re: Geotechnical Grading and Site Servicing Plans Review
Proposed Industrial Development
295 Roger Neilson Way - Ottawa, Ontario

date: August 27, 2026

file: PG7845-MEMO.02

FIGURE 1

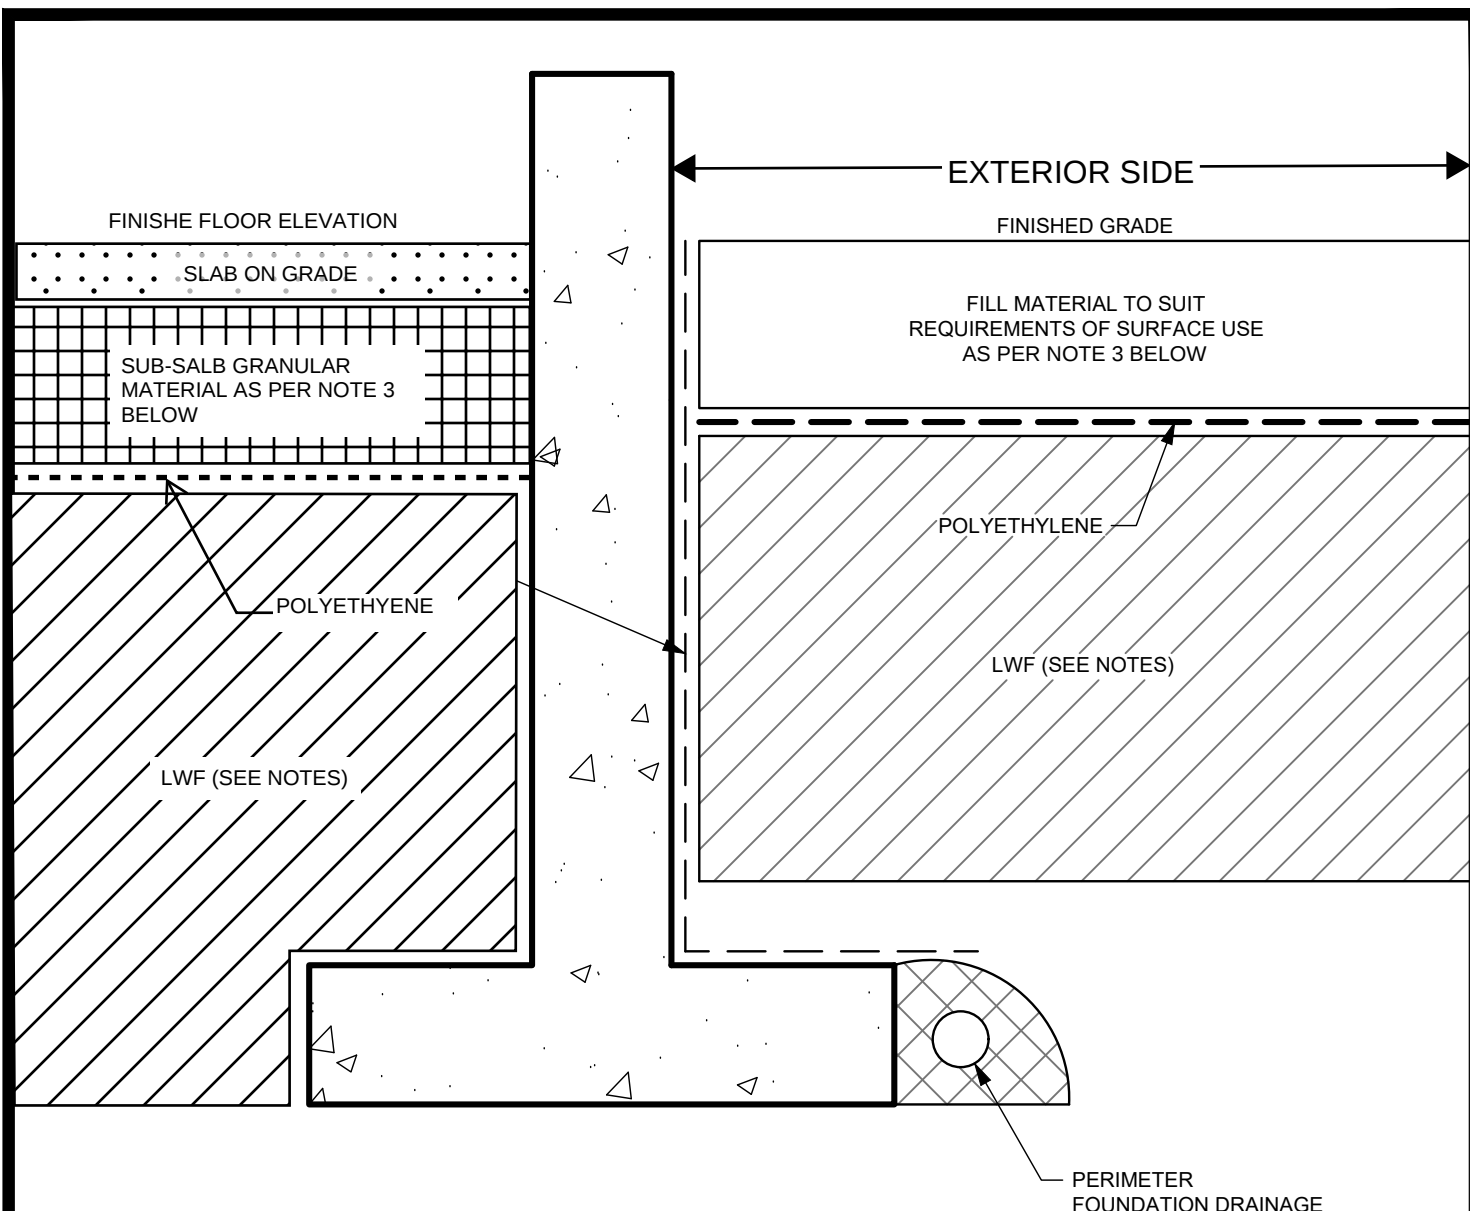
Reference should be made to Figure 1 – EPS Block Installation Recommendations and Figure 2 – Marked-Up Grading Plan, which indicate the required locations, extents, and thicknesses of the LWF.

It shall be noted that the LWF shall not extend vertically below the USF. The LWF should consist of EPS (expanded polystyrene) geofoam blocks, which allow for raising the grade without adding a significant load to the underlying soils. For this application, EPS type 15 should be used.

1. USE EPS12 BELOW LANDSCAPED AREAS
2. USE EPS15 BELOW GARAGE DRIVEWAY AND INTERIOR AREA
3. MINIMUM GRANULAR THICKNESS OVER LWF SHOULD BE AS FOLLOWS:

FRONT PORCH	150mm OF OPSS GRANULAR A
GARAGE	300mm OF OPSS GRANULAR A
DRIVEWAY	450mm OF OPSS GRANULAR A
LANDSCAPED	500mm OF APPROVED BACKFILL SOIL
INTERIOR AREA	300mm OF OPSS GRANULAR A
4. PLACEMENT OF LWF SHOULD BE ON A LEVELED SURFACE (SAND CAN BE USED TO PROVIDE AN ADEQUATE LEVELLING SURFACE).

Figure 2 – Marked-Up Grading Plan

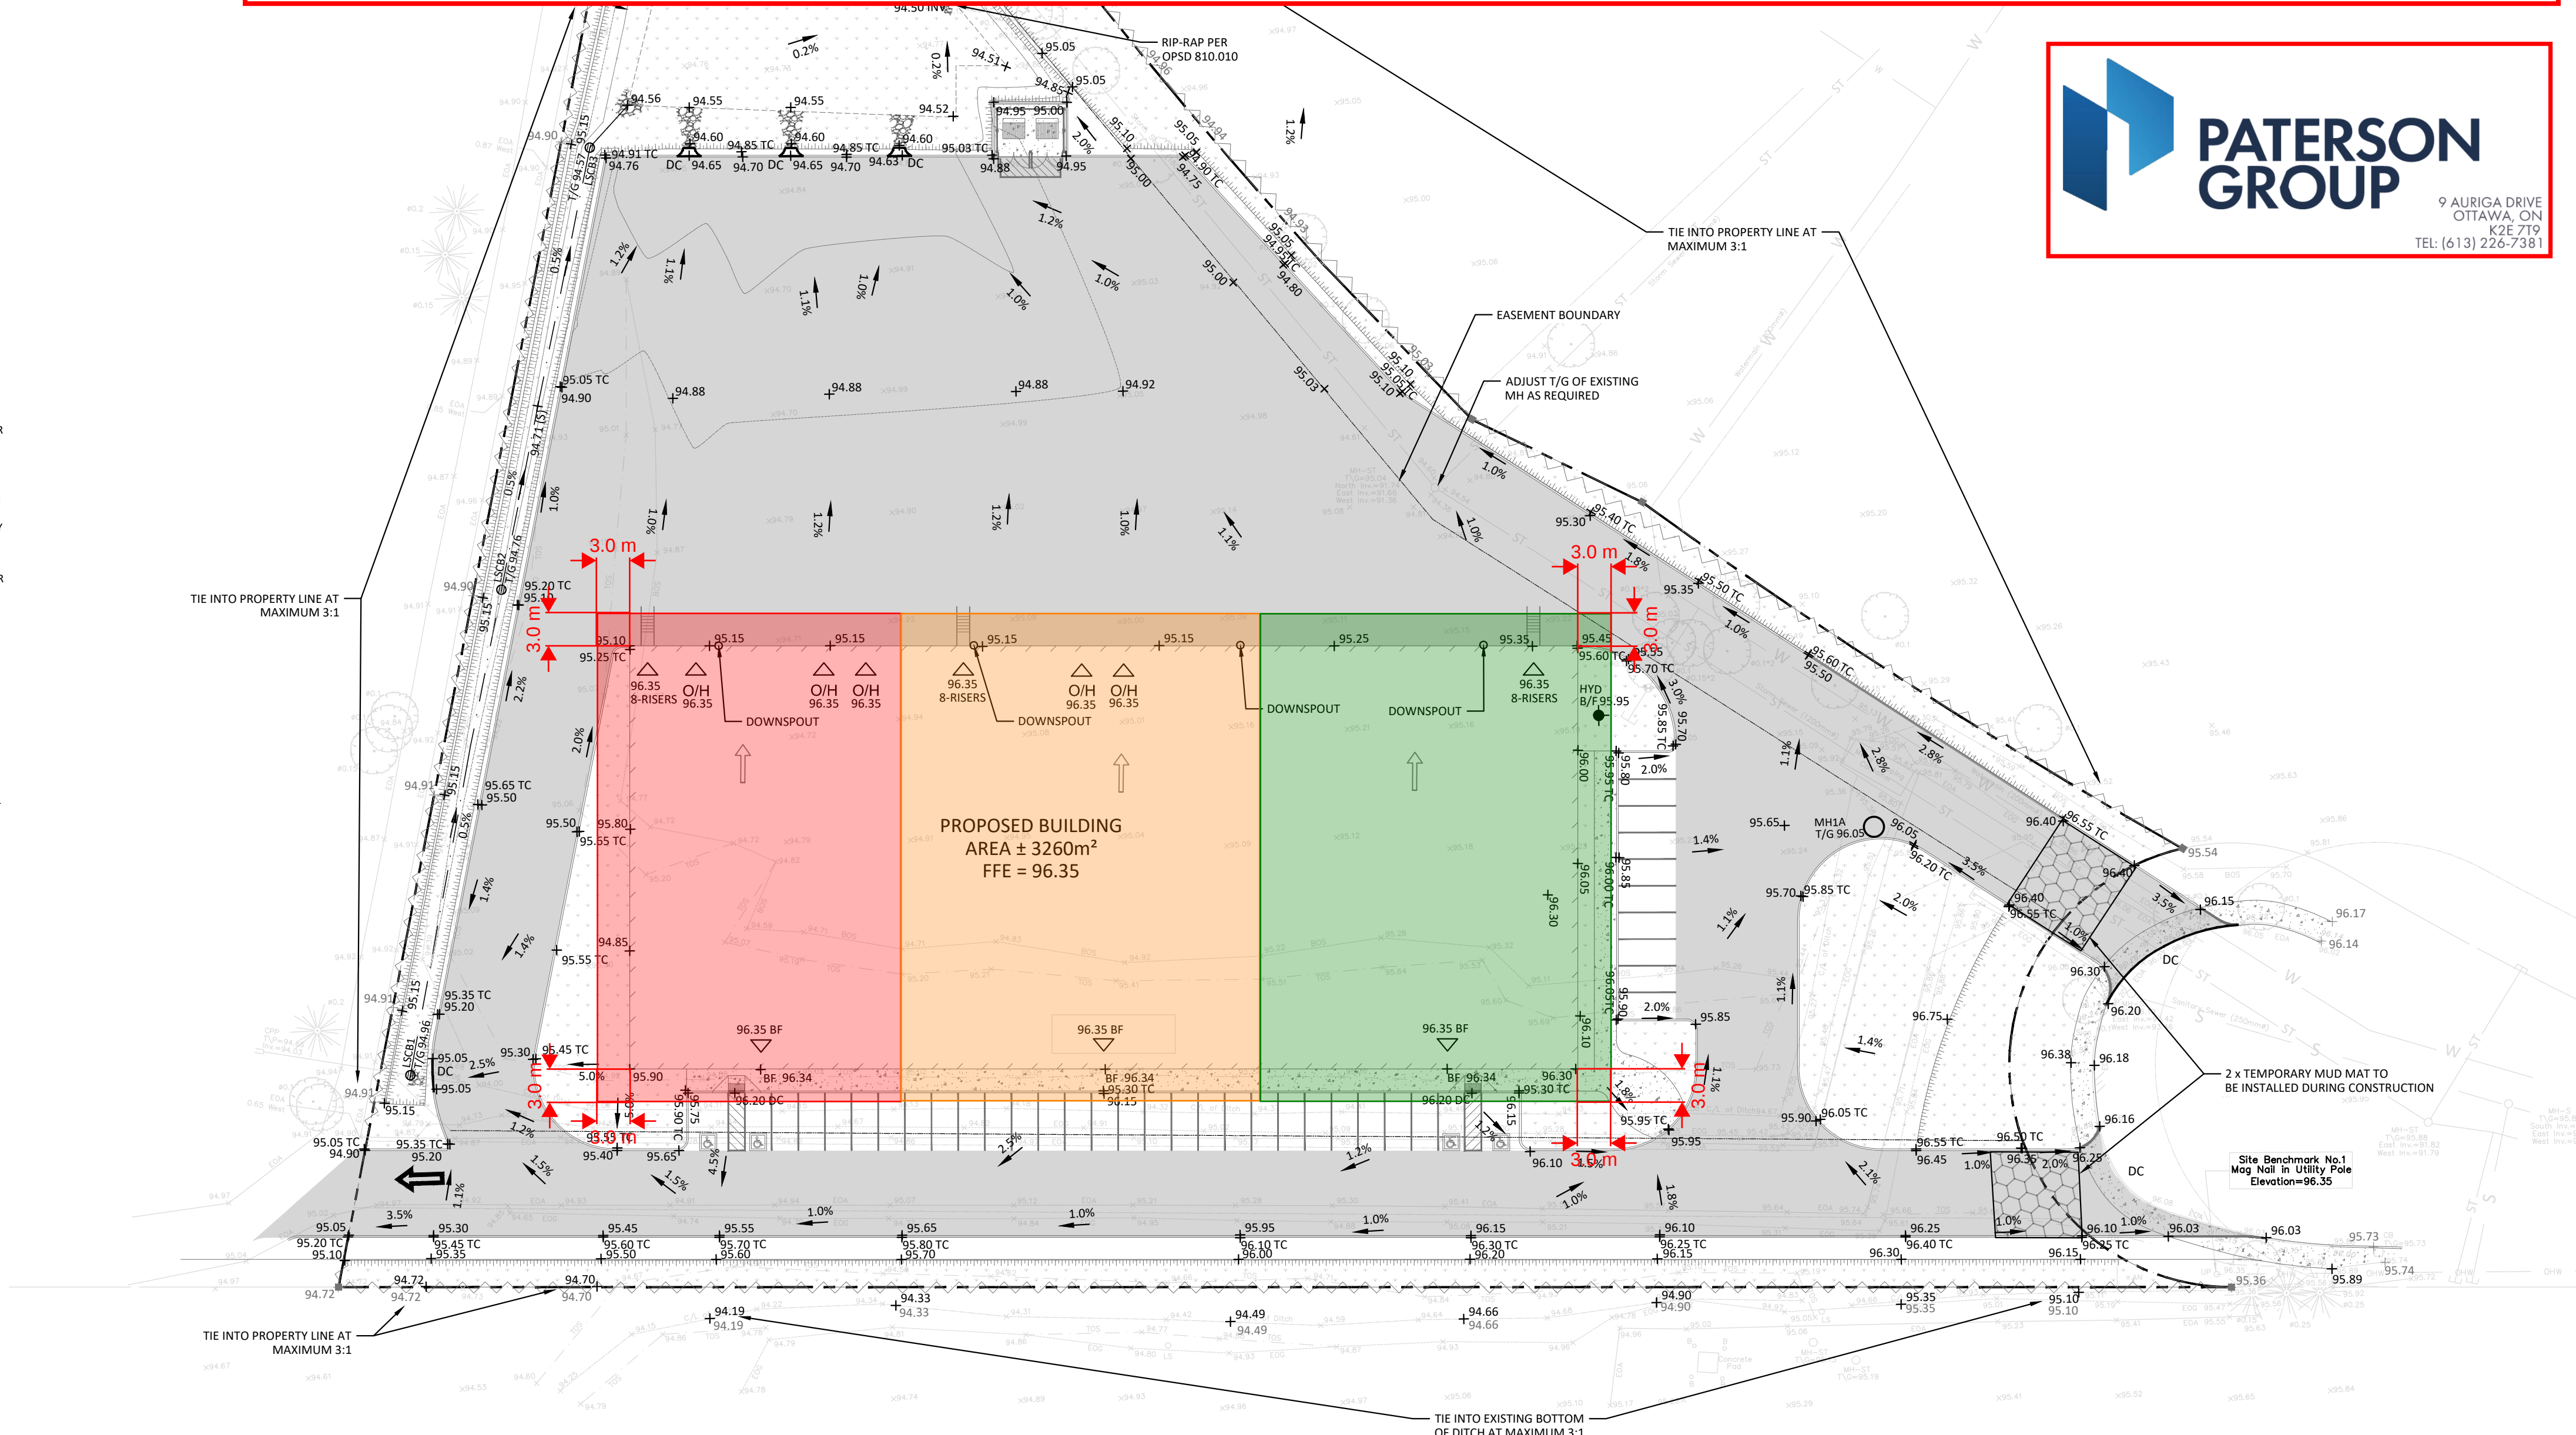
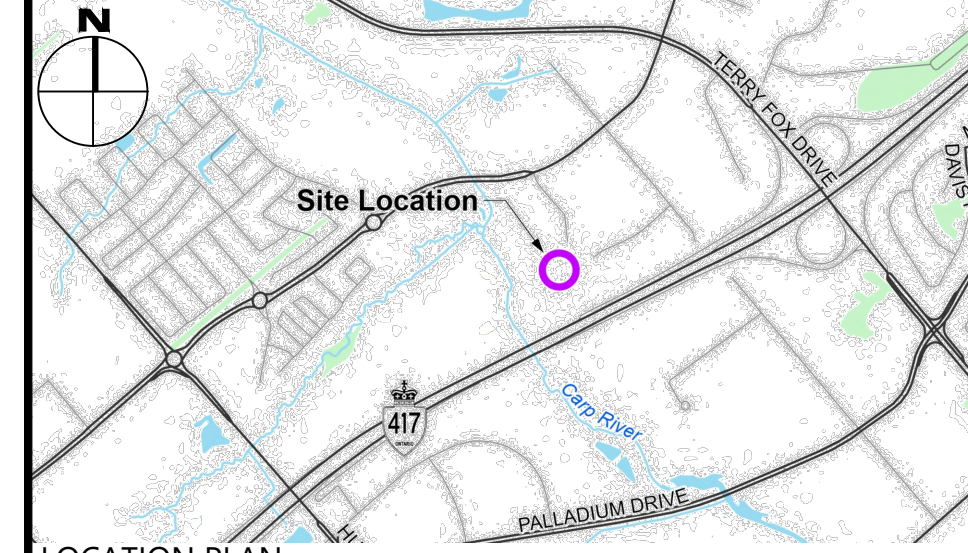
Paterson has reviewed the subsurface conditions within the footprint(s) of the proposed building. Based on our review, **a permissible grade raise restriction of 0.5 m** is recommended in the proposed building footprint and within 3 m of the building perimeter. This accounts for a live load on the slab-on-grade of 12 kPa. If the actual live load on the slab-on-grade differs from this value, then this permissible grade raise value would need to be adjusted. Beyond the 3 m distance from the proposed building perimeter, **a permissible grade raise restriction of 1.2 m** is recommended.

Based on our review of the above-noted drawing, the proposed grading for the parking areas, access roads, and landscaped areas beyond 3 m of the proposed building footprint is within the permissible 1.2 m grade raise. However, based on the finished floor elevations and proposed grading around the building, lightweight fill (LWF) should be placed below and around the proposed building footprint. The LWF should be installed at the minimum thickness, locations, and extents shown on Figure 2 attached to this memorandum.

- Minimum 1.1 m thick layer of EPS 15 geofam lightweight fill blocks should be placed and extend horizontally a minimum 3 m beyond foundation walls.
- Minimum 0.9 m thick layer of EPS 15 geofam lightweight fill blocks should be placed and extend horizontally a minimum 3 m beyond foundation walls.
- Minimum 0.7 m thick layer of EPS 15 geofam lightweight fill blocks should be placed and extend horizontally a minimum 3 m beyond foundation walls.
